ADDENDUM NO. 1 TO PROJECT NO. 45404

**CONSTRUCTION, HVAC, PLUMBING AND ELECTRICAL WORK
PROVIDE BATTALION HEADQUARTERS, BUILDING 75
CAMP SMITH TRAINING SITE
11 BEAR MOUNTAIN BRIDGE ROAD
CORTLANDT MANOR, NY 10567**

August 18, 2016

A3/A-302 REVISED SECTION - DOOR HEAD & THRESHOLD

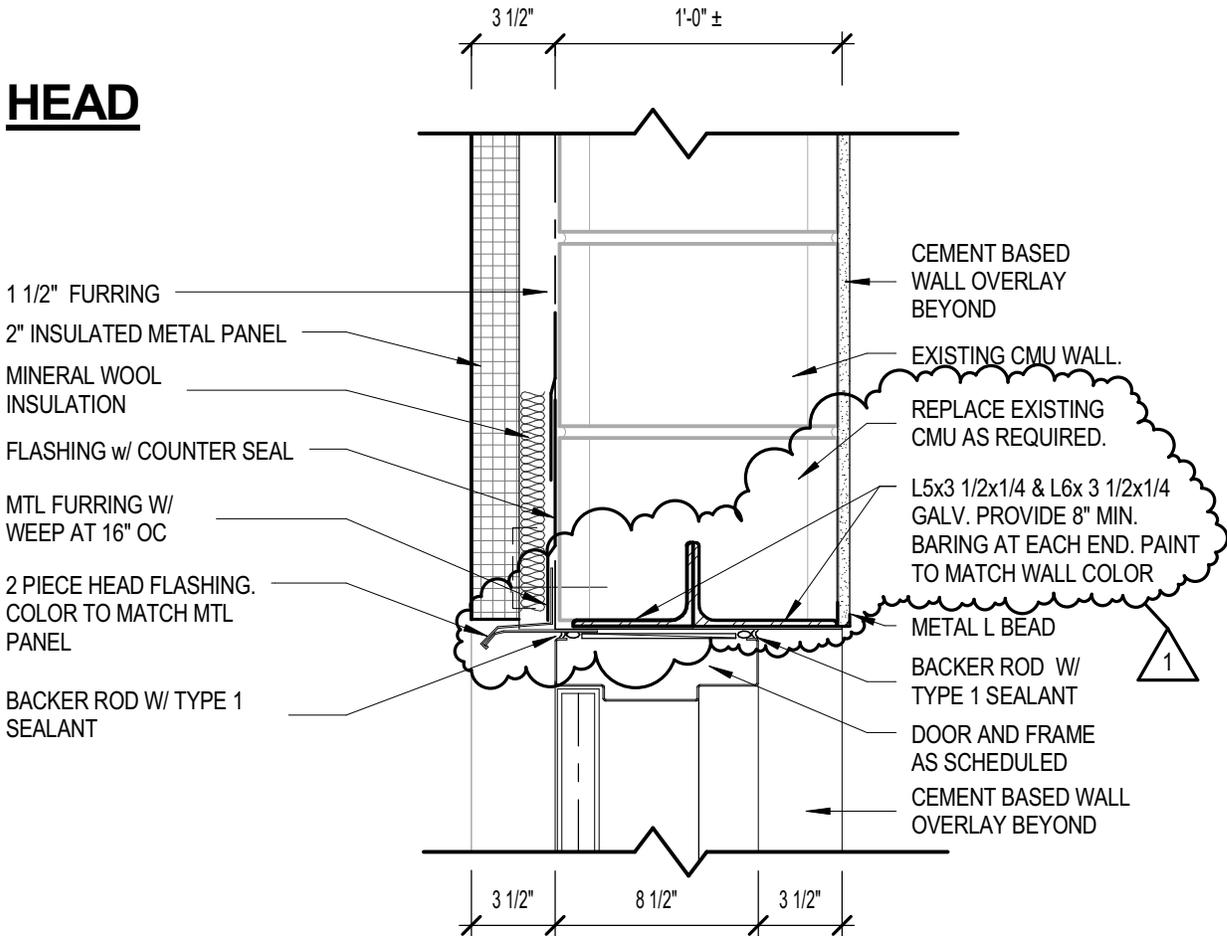
- a. Detail A1; Revise detail with JD-A15 Addendum Drawing dated 10 Aug 2016.
- b. Detail A3; Revise detail with JD-A14 Addendum Drawing dated 10 Aug 2016.
- c. Details A4 and A5; Revise details with JD-A13 Addendum Drawing dated 10 Aug 2016

SHEET TITLE:
A-401 REVISED GUARDRAIL DETAILS

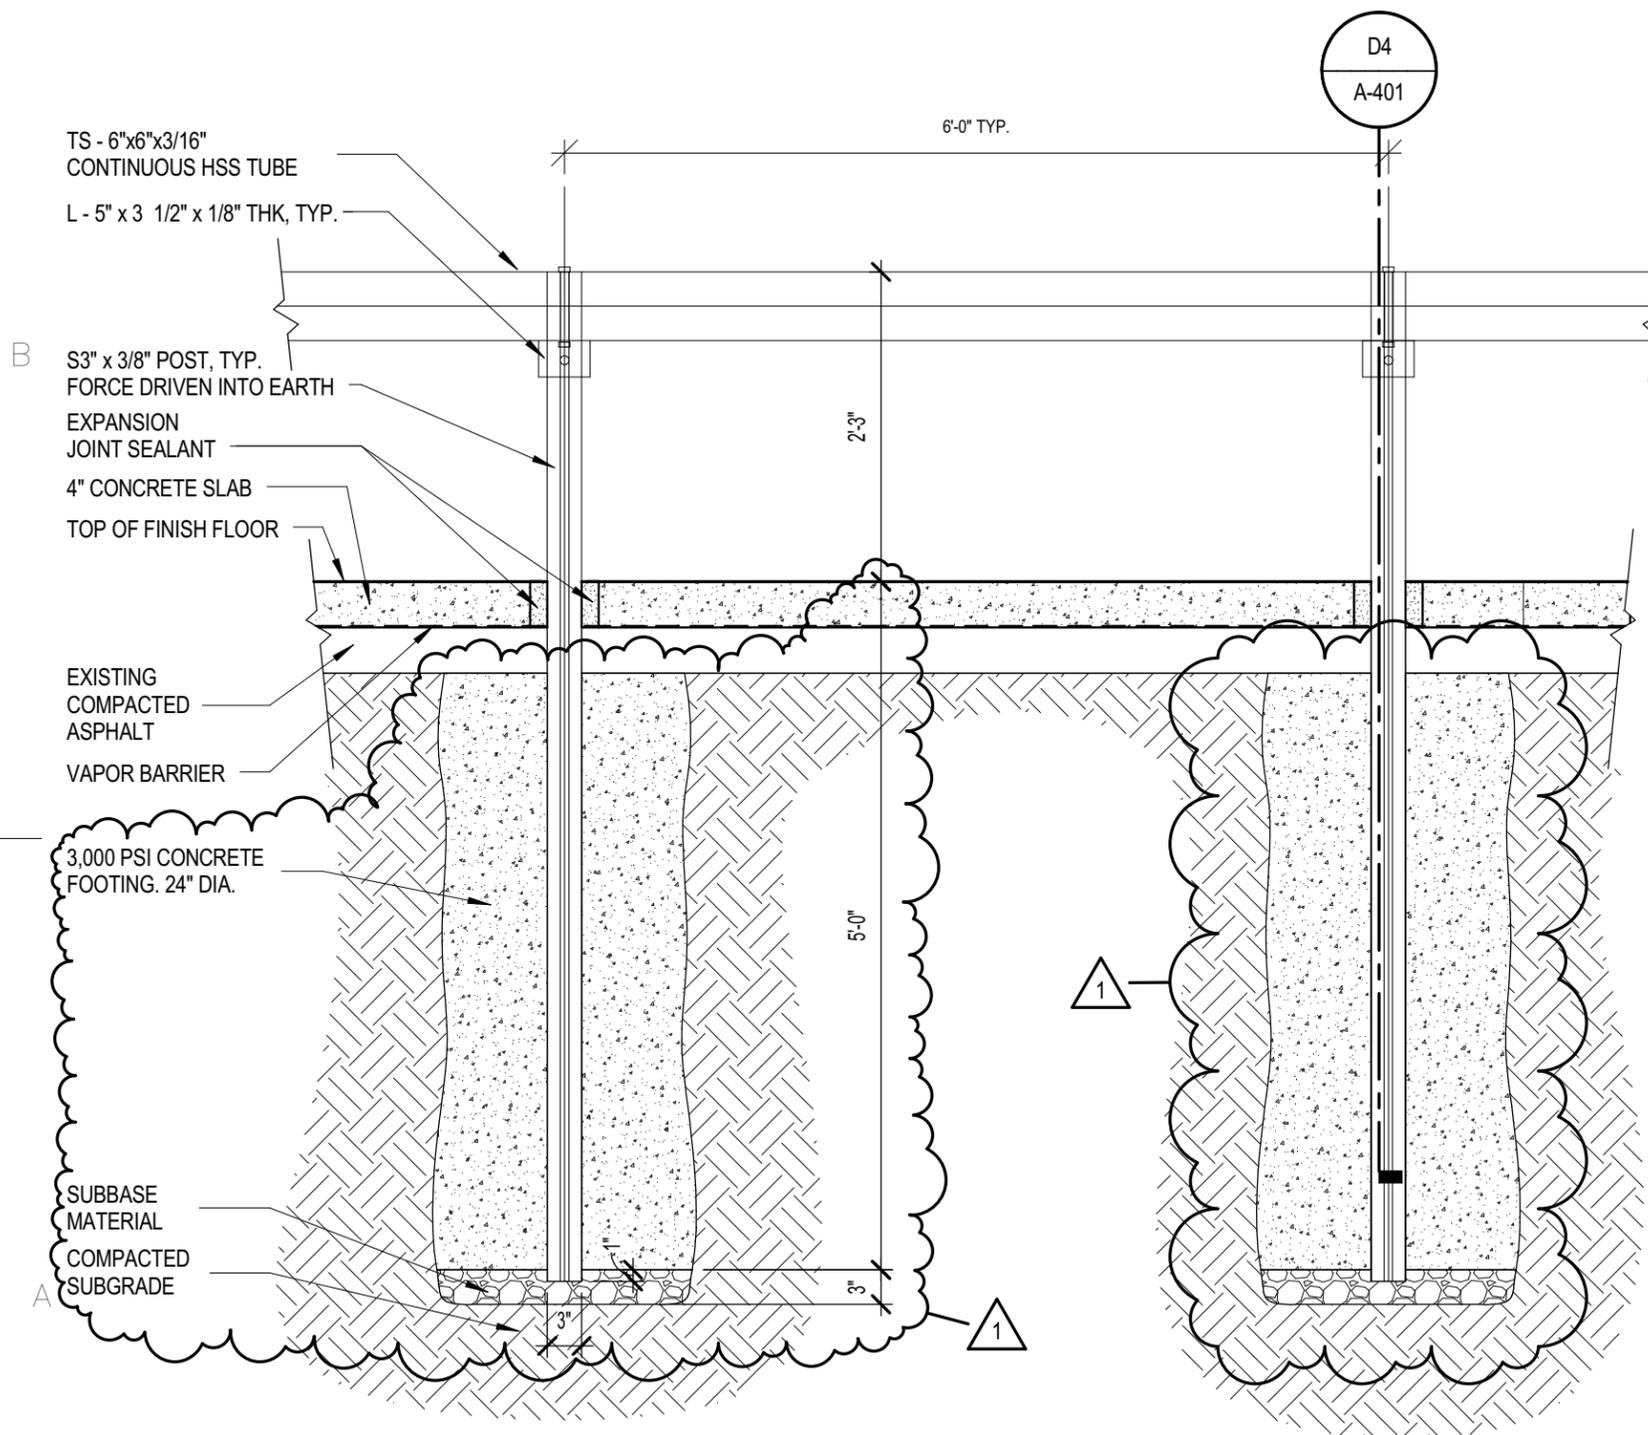
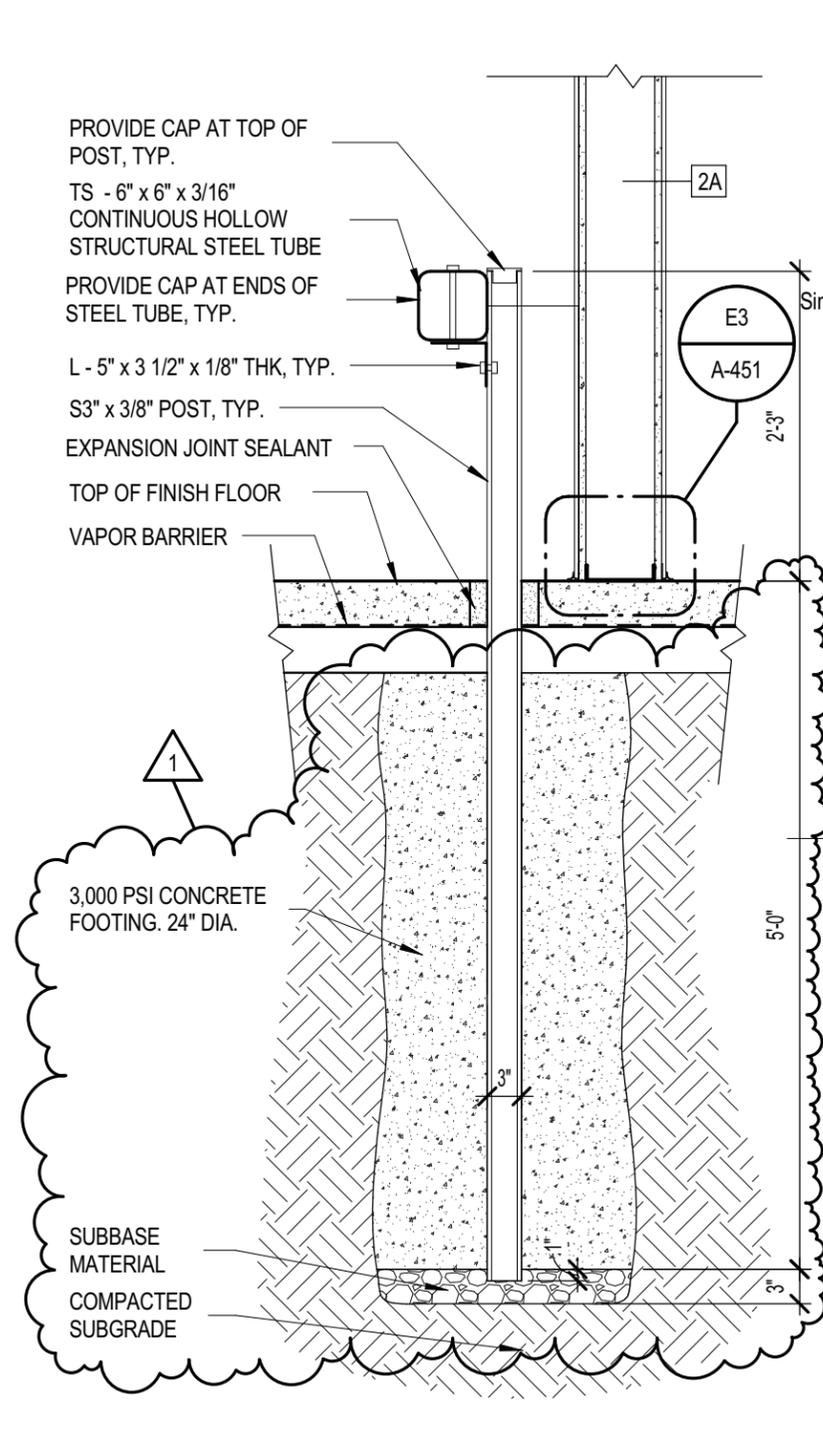
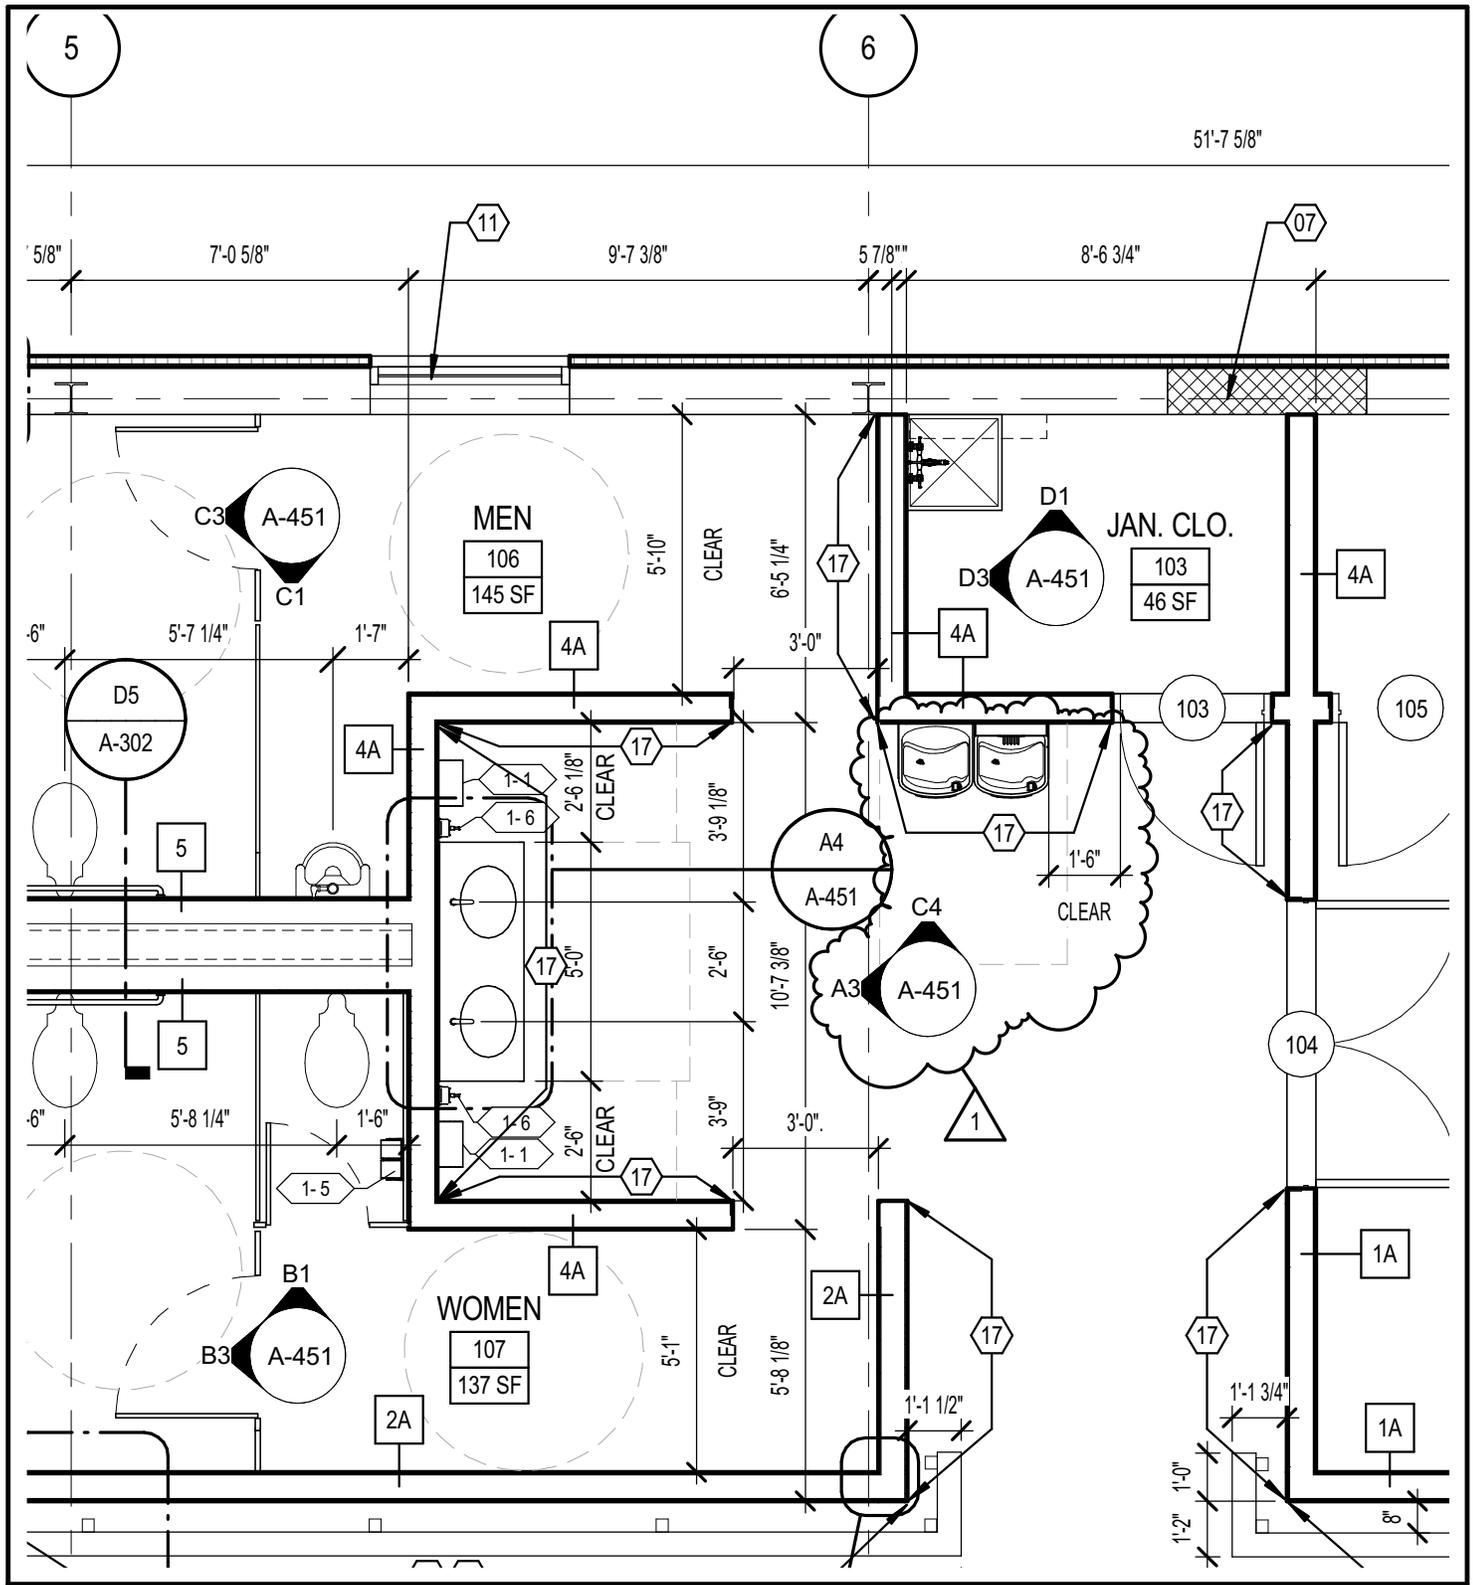
- a. Details D3 and D4; Replace with JD-A16 Addendum Drawings dated 10 Aug 2016.
- b. Enlarged Floor Plan A1; Add elevation symbol for drinking fountain elevation, see JD-A17 drawing dated 10 Aug 2016.

A1/A-451 REVISED TYPICAL ACCESSORY MOUNTING HEIGHTS

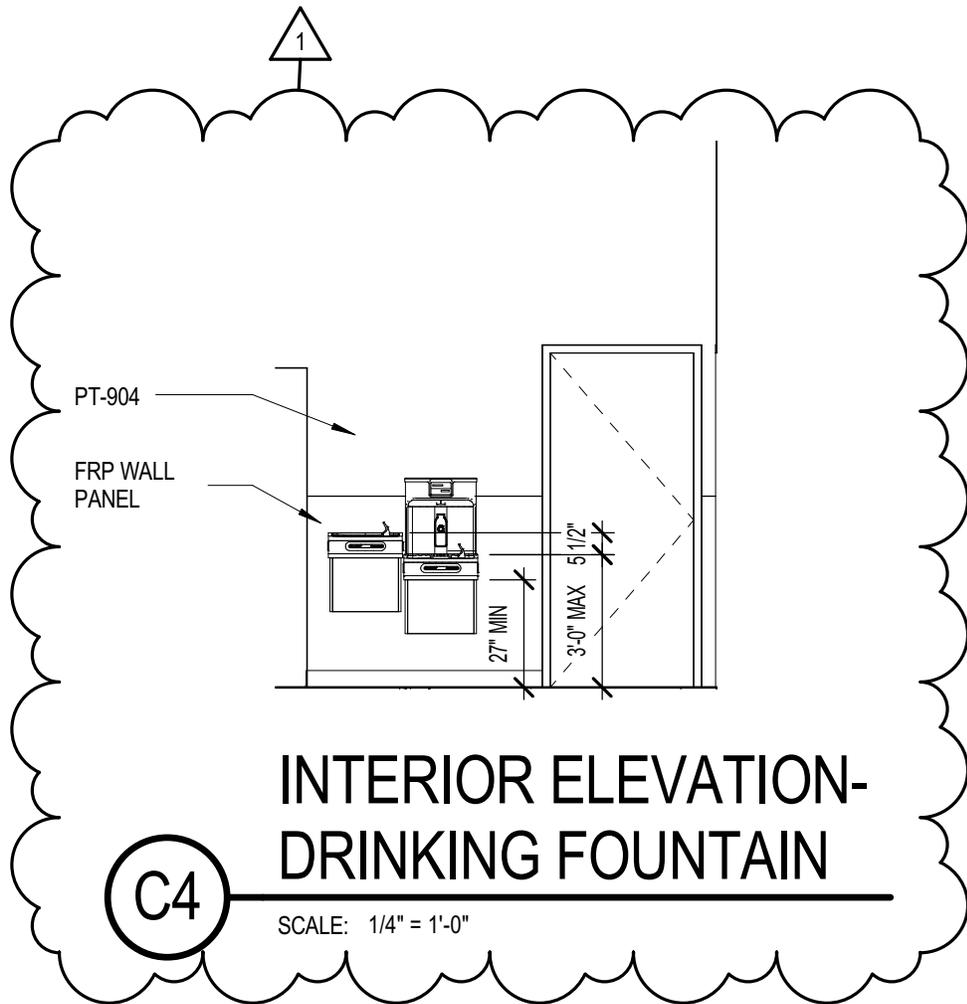
- a. Detail A3; Replace detail with JD-A18 Addendum Drawing dated 10 Aug 2016.
- b. Detail A1; Replace detail with JD-A19 Addendum Drawing dated 10 Aug 2016.
- c. Add Detail C4/A-451. See JD-A20 Addendum Drawing dated 10 Aug 2016.
- d. Detail C1; Replace detail with JD-21 Addendum Drawing dated 10 Aug 2016.
- e. Schedule – Toilet and Misc Accessories; revise with JD-A22 Addendum Drawing dated 10 Aug 2016.
- f. Schedule-Toilet and Misc Accessories: Add note under schedule "THIS SCHEDULE IS ALSO APPLICABLE TO ENLARGED FLOOR PLAN A1/A-401".

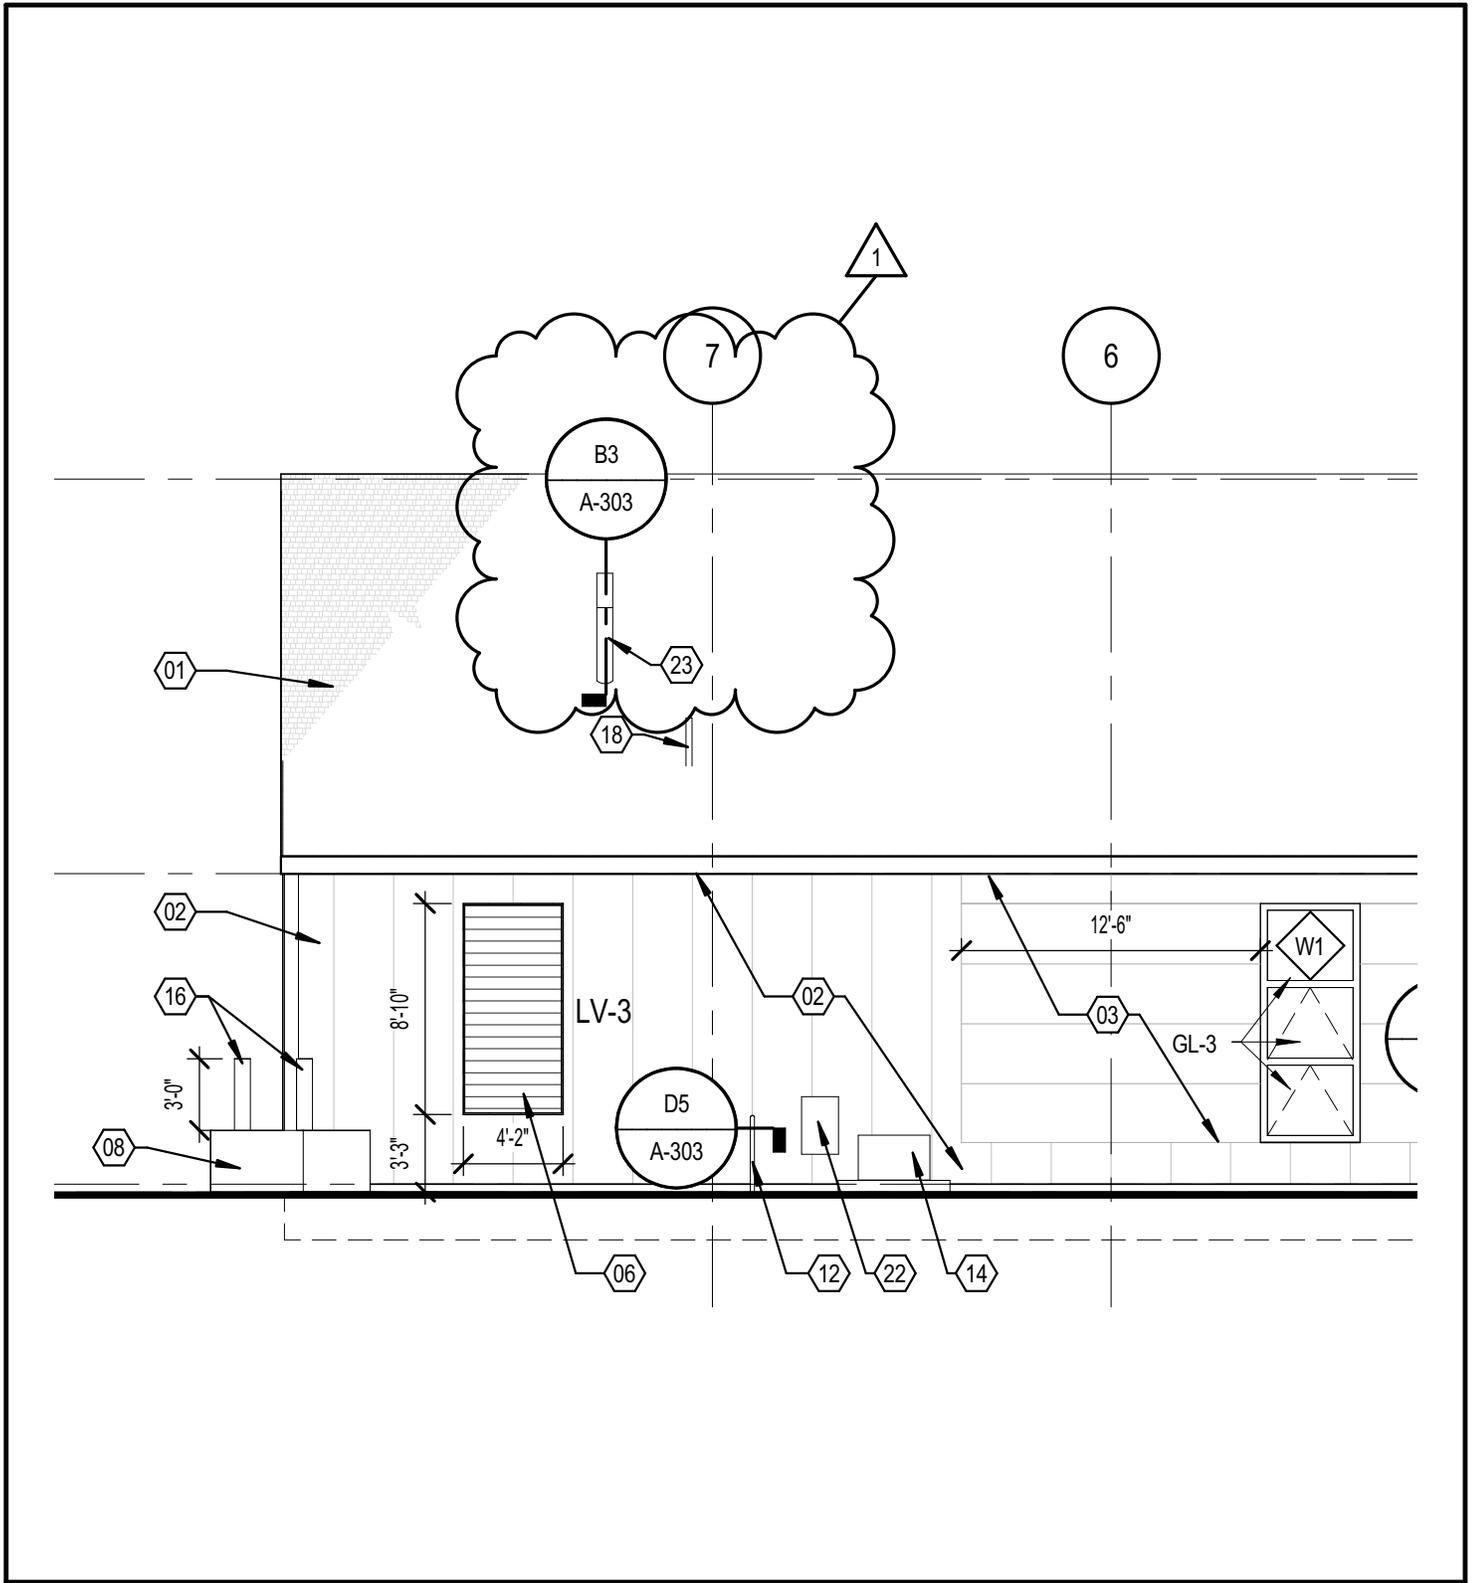
- a. Detail D1; Replace detail with JD-A27 Addendum Drawing dated 10 Aug 2016.
- b. Detail B3; Add detail with JD-A23 Addendum Drawing dated 10 Aug 2016.
- e. Detail D4; Replace detail with JD-A29 Addendum Drawing dated 10 August 2016.
- f. Detail D5; Revise sealant type to read "SEALANT TYPE 1, BOTH SIDES".
